Crystal River Nuclear Plant
Docket No. 50-302
Operating License No. DPR-72

Subject: Crystal River Unit 3 – Response to Request for Additional Information to Support NRC Safety Issues Resolution Branch (SSIB) Technical Review of the CR-3 Extended Power Uprate LAR (TAC No. ME6527)

**RESPONSE TO REQUEST FOR ADDITIONAL INFORMATION
– SAFETY ISSUES RESOLUTION BRANCH TECHNICAL
REVIEW OF THE CR-3 EPU LAR**

Figure 1
Proposed Low Pressure Injection System Cross-Tie
and Hot Leg Injection Simplified Diagram

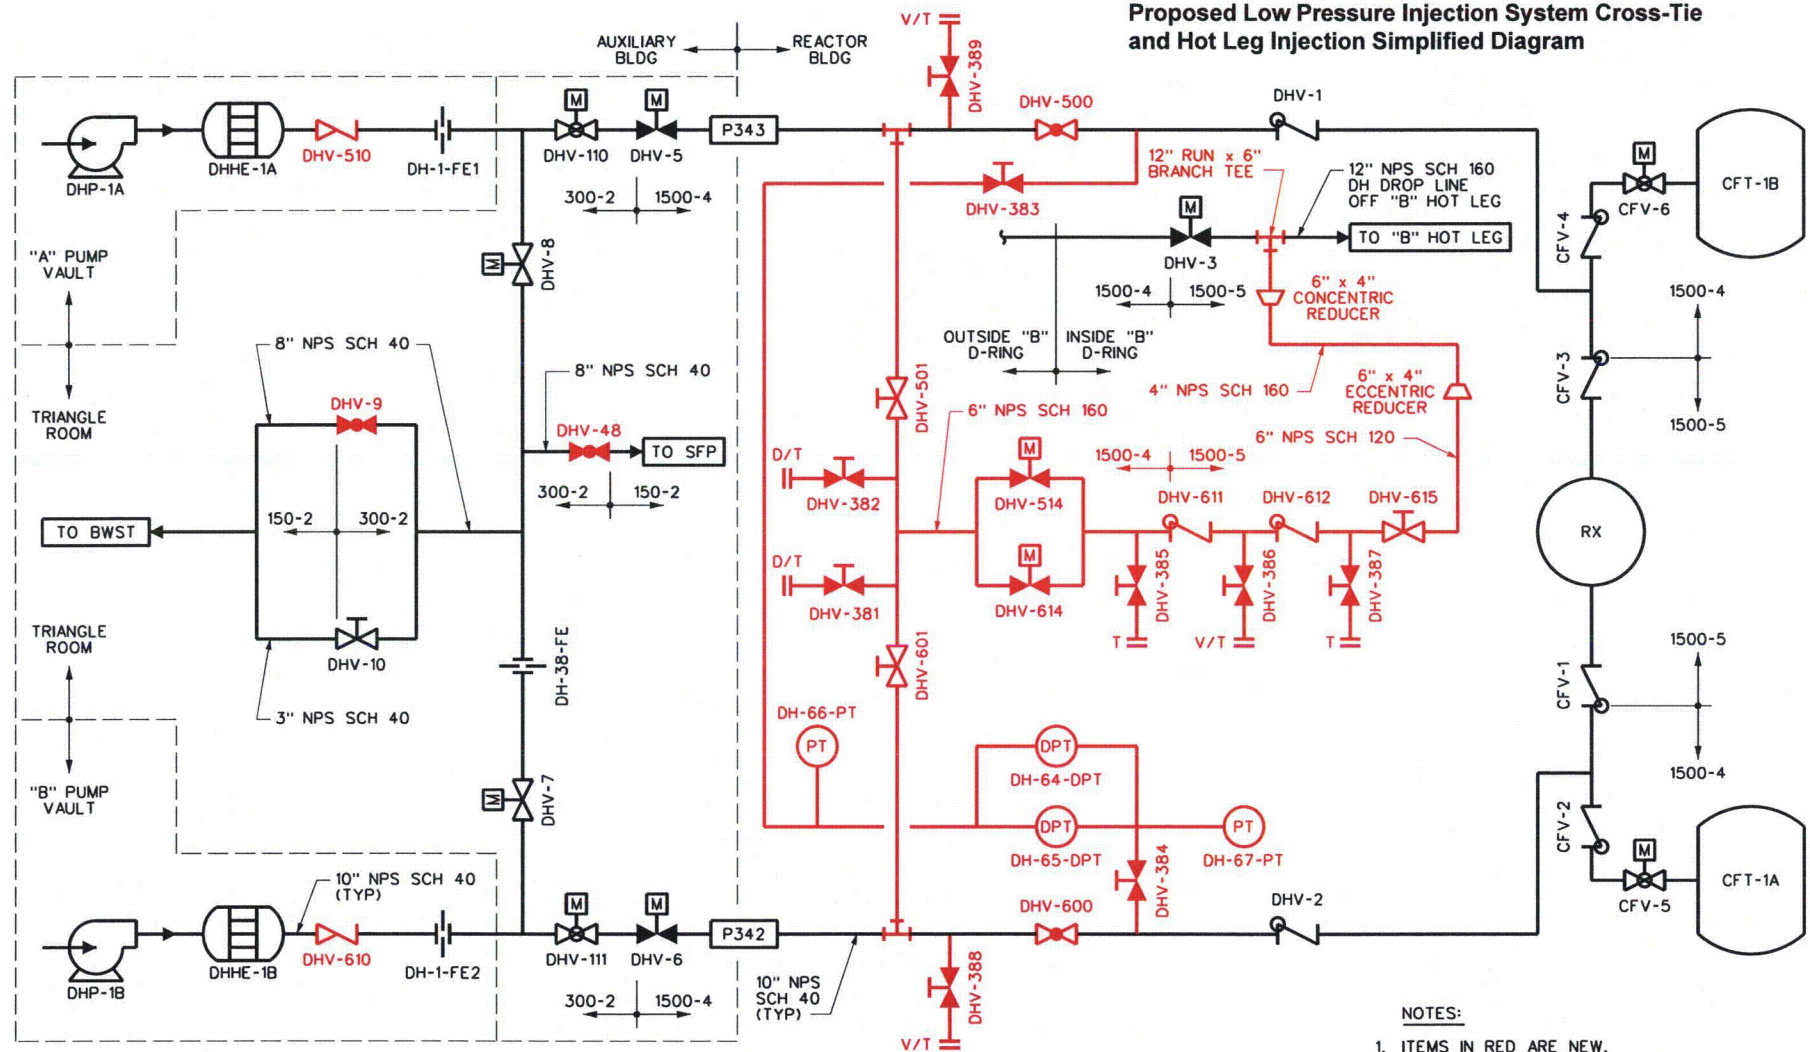
With regard to resolving issues identified in the NRC Generic Safety Issue 191, "Assessment of Debris Accumulation on Pressurized-Water Reactor Sump Performance," Attachment 5 of the original EPU LAR dated June 15, 2011, Section 2.8.5.6.3 cites NRC correspondence dated October 2, 2009 (Farideh E. Saba (NRC) Letter to Jon A. Franke (Progress Energy)), Crystal River Unit 3 Nuclear Generating Plant - Partial Close out and Request for Additional Information Related to Generic Letter 2004-02 (TAC NO. MC4678), ADAMS Accession No. ML092670261) to show that with the exception of in-vessel downstream effects, CR-3 has resolved the issues identified in Generic Safety Issue-191.

Consistent with the guidance in the NRC staff's safety evaluation on Nuclear Energy Institute [NEI]-04-07, the equipment in the emergency core cooling system (ECCS) and containment spray system, such as pumps and valves, at CR-3 has been evaluated for the effects of debris in the recirculated fluid that bypasses (or passes through) the suction strainers. The power uprate submittal states that valves and piping are being added to the ECCS to support a passive cross-tie between the decay heat removal/low-pressure injection system and reactor cooling system hot-leg B. Please describe the method(s) used to evaluate the new piping system components for blockage and wear and the results of those evaluations.

The new valves for the Low Pressure Injection (LPI) System cross-tie and the hot leg injection (HLI) modification have been assessed for blockage and erosive wear against the wear and plugging criteria of NRC approved topical report WCAP-16406-P-A, "Evaluation of Downstream Sump Debris Effects in Support of GSI-191," (Reference 2). Figure 1, "Proposed Low Pressure Injection System Cross-Tie and Hot Leg Injection Simplified Diagram," illustrates the new valves and instrument sensing lines proposed for installation in the CR-3 LPI System cross-tie and HLI modification.

The new LPI cross-tie modification design includes the following:

- Two Flex Wedge normally open, 10 inch gate valves (DHV-501, 601). The valves provide a full port flow path through the cross-tie line. Plugging and wear impact are not considered critical per Section 8.2, "Valves," of WCAP-16406-P-A.

- Two Y-pattern manual 10 inch globe valves (DHV-500, 600). These manual valves will be locked in a throttled position following flow balancing of the system. It is expected that these valves will be throttled approximately 50% open to establish at least 3000 gpm. FPC has assessed the plugging and wear impact of these valves and concluded that adequate margin exists to account for fine tuning of the valve throttle position during flow balancing. These valves will meet the plugging and wear acceptance criteria of Sections 7.3.3, "Flow Area Evaluation for Plugging and Wear," and 7.3.2, "Erosive Wear," of WCAP-16406-P-A, respectively.

- Two Y-pattern globe style, 10 inch stop check valves (DHV-510, 610). These valves will change position based on pump discharge flow and prevent reverse flow through an idle pump, if necessary. Since these check valves are > 1 inch, and the minimum required flow through the valves is normal LPI System flow (i.e., > 0.42 ft/sec), plugging and wear impact are not considered critical per Section 8.2 of WCAP-16406-P-A.

The new HLI line modification design includes the following:

- Two normally closed motor-operated, parallel slide, 6 inch gate valves (DHV-514, 614). The valves are required to open in certain post-accident scenarios to support boron precipitation mitigation in the core. These gate valves are > 1 inch and are either fully open or fully closed; thus, plugging and wear impact are not considered critical per Section 8.2 of WCAP-16406-P-A.

- One manual normally open, 6 inch Flex Wedge gate valve (DHV-615) provides a full port flow path through the new HLI line. This gate valve is > 1 inch and is normally fully open; thus, plugging and wear impact are not considered critical per Section 8.2 of WCAP-16406-P-A.

- Two normally closed, 6 inch, nozzle check valves (DHV-611, 612) will open to pass process flow in certain post-accident scenarios to support boron precipitation mitigation in the core. Since these check valves are > 1 inch, and the minimum required flow through the valves is 400 gpm (i.e., > 0.42 ft/sec), plugging and wear impact are not considered critical per Section 8.2 of WCAP-16406-P-A.

- Two normally closed, 8 inch, T-pattern, manual globe valves (DHV-9, 48) in the process lines to the spent fuel pool and the borated water storage tank. These normally closed test valves are > 1.5 inches; thus, plugging and wear impact are not considered critical per Section 8.2 of WCAP-16406-P-A.

- The new LPI System pressure instruments (DH-64-DPT, DH-65-DPT, DH-66-PT, and DH-67-PT) utilize 0.5 inch, stainless steel tubing for impulse sensing lines to connect to the LPI System piping downstream of throttle valves DHV-500 and DHV-600. Since the impulse sensing instrument lines are static fluid lines and have no discernible flow, the only credible

method causing the instrument sensing lines to become plugged would be caused by settling debris in the lines. Therefore, the LPI System cross-tie line modification design includes connecting the 0.5 inch sensing line perpendicular to the main 10 inch LPI System piping at the pipe horizontal center-line, which will ensure the sensing lines remain water-solid minimizing the possibility of debris entrapment and settling in the sensing lines. Thus, the LPI System pressure impulse sensing line design meets the criteria specified in Section 8.6.6, "Sensing Line Evaluation," of WCAP-16406-P-A.
